22-GRAD-0005  
Application # 8291

22-ENRV-0008  
Application # 8228

SHEET NO. SP1

SITE PLAN FOR 004854-000-047-00

SITE PLAN  
SCALE: 1" = 10'

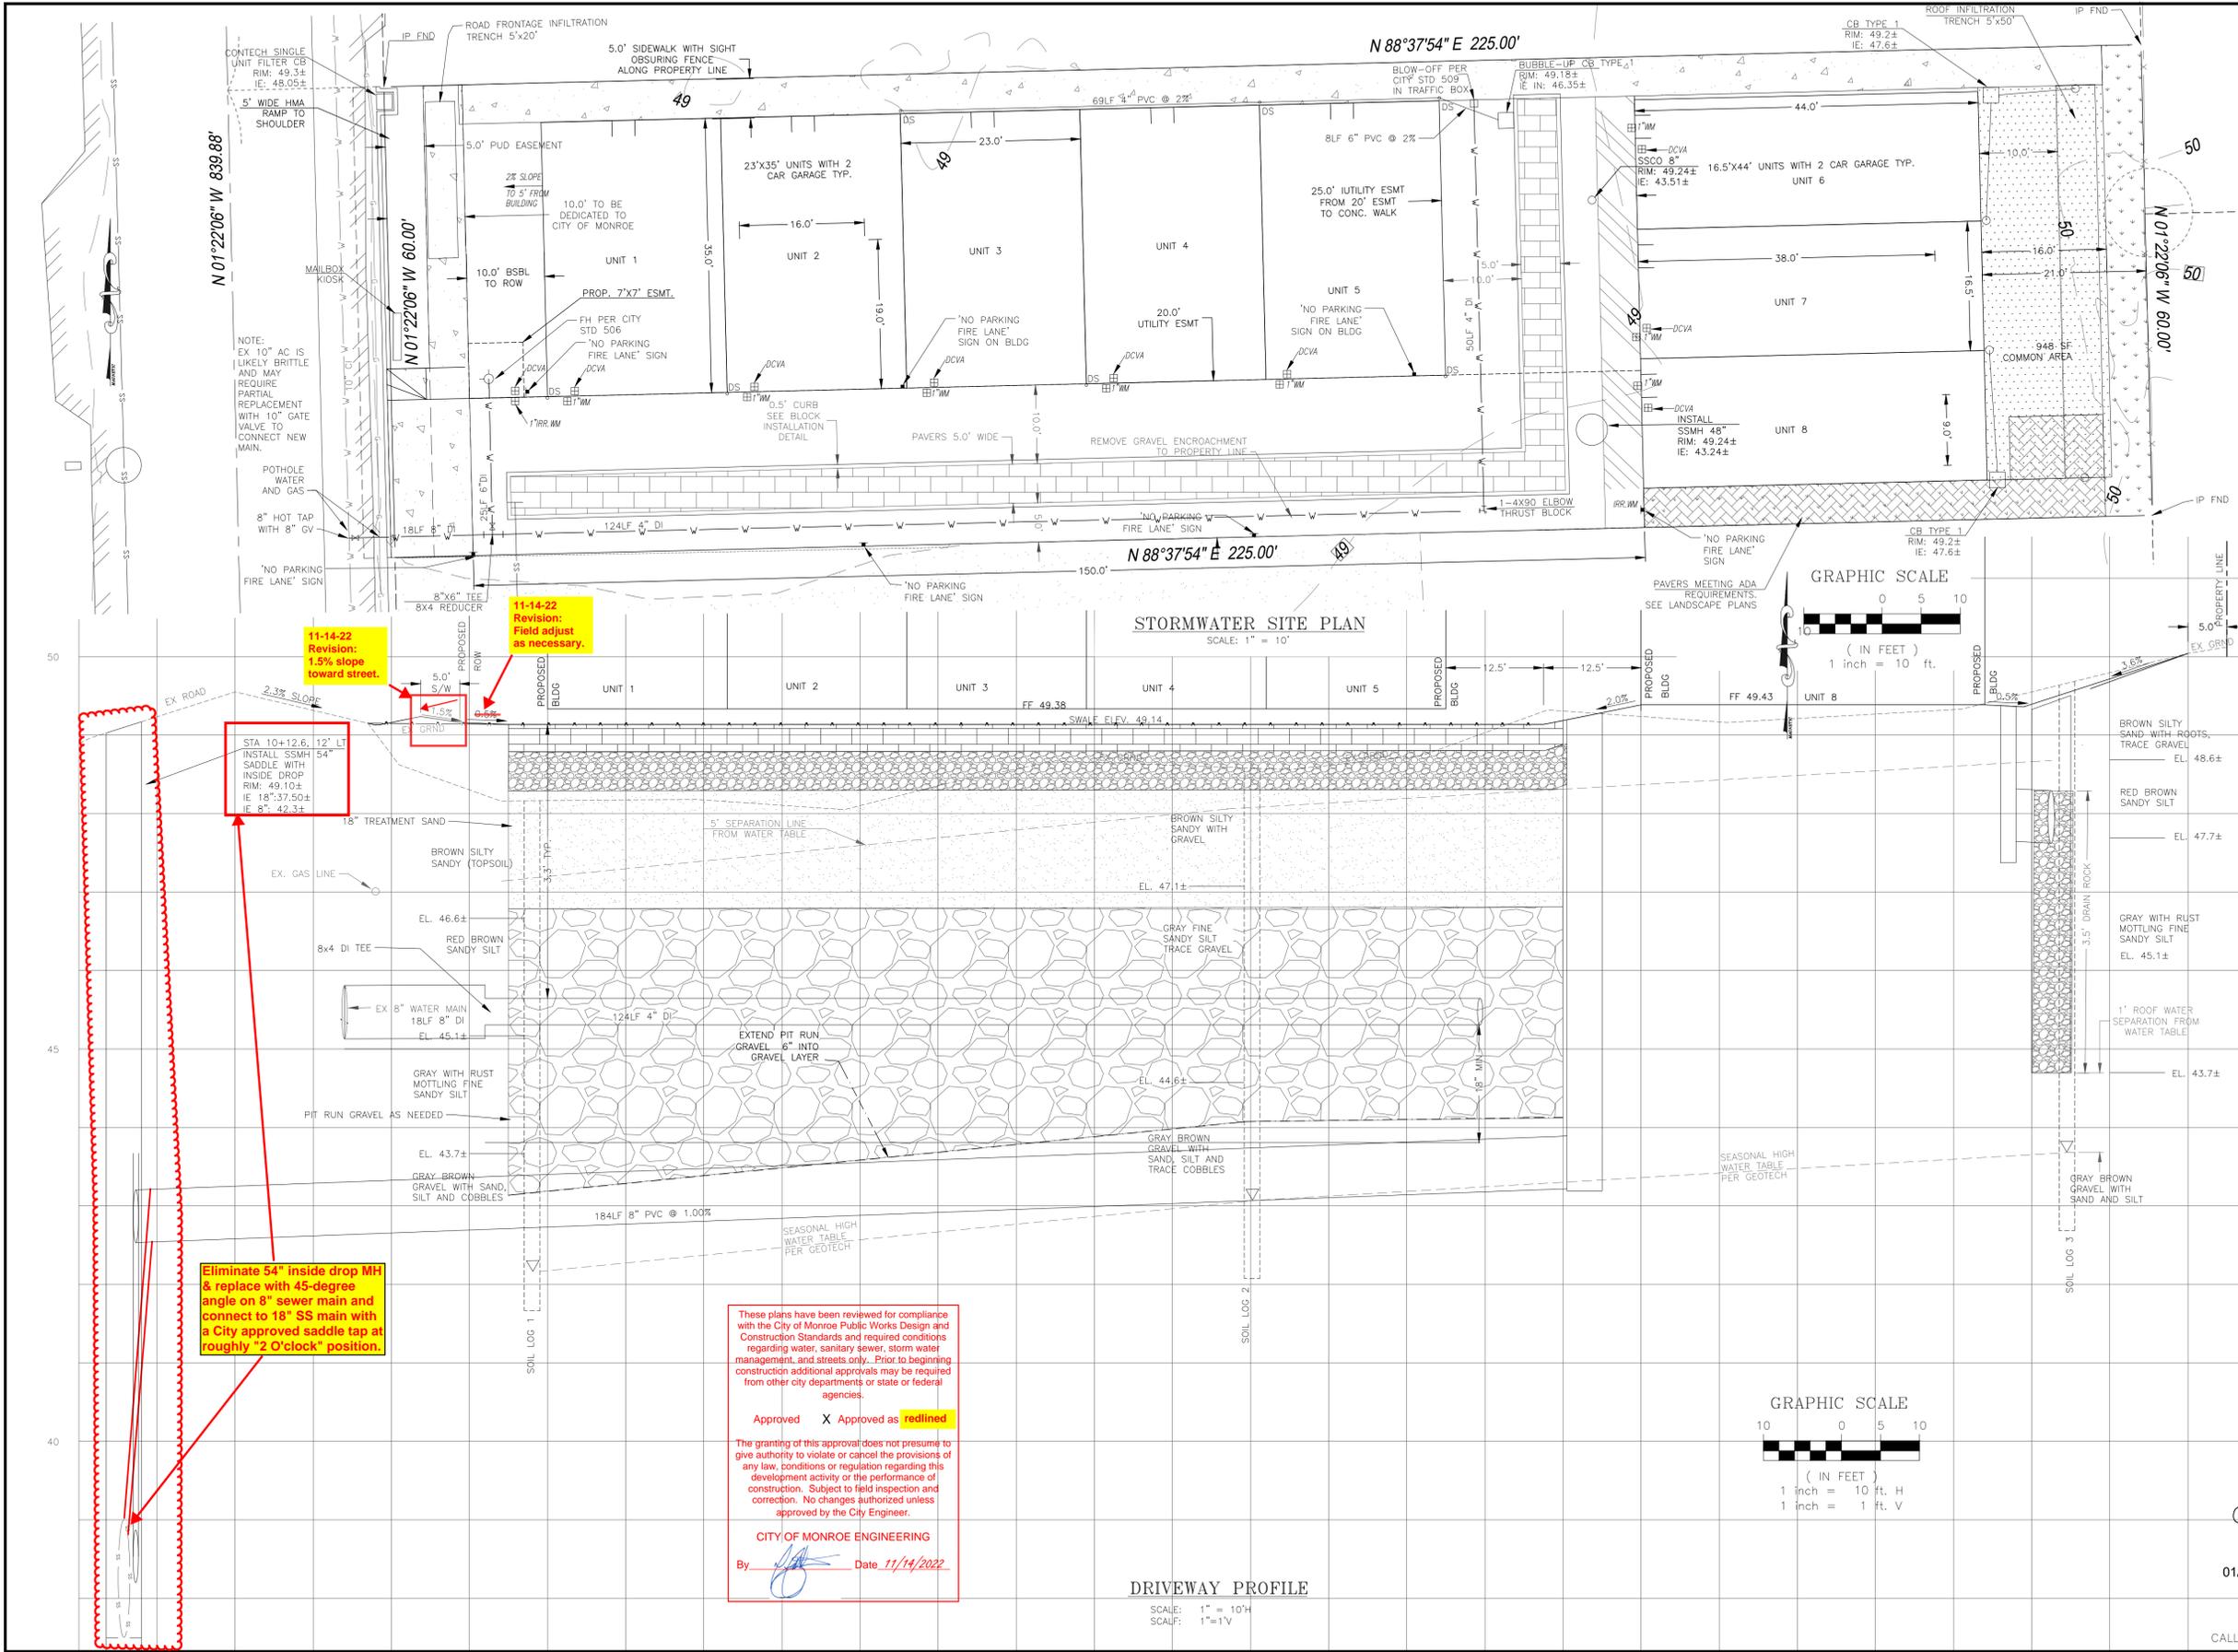
A concrete sidewalk may be installed in this clouded area to provide required access to public sidewalk on 179th Ave SE. As of 3/4/2022 the owner has not made a decision. If constructed, it must meet same requirements as commercial driveway for fire trucks.
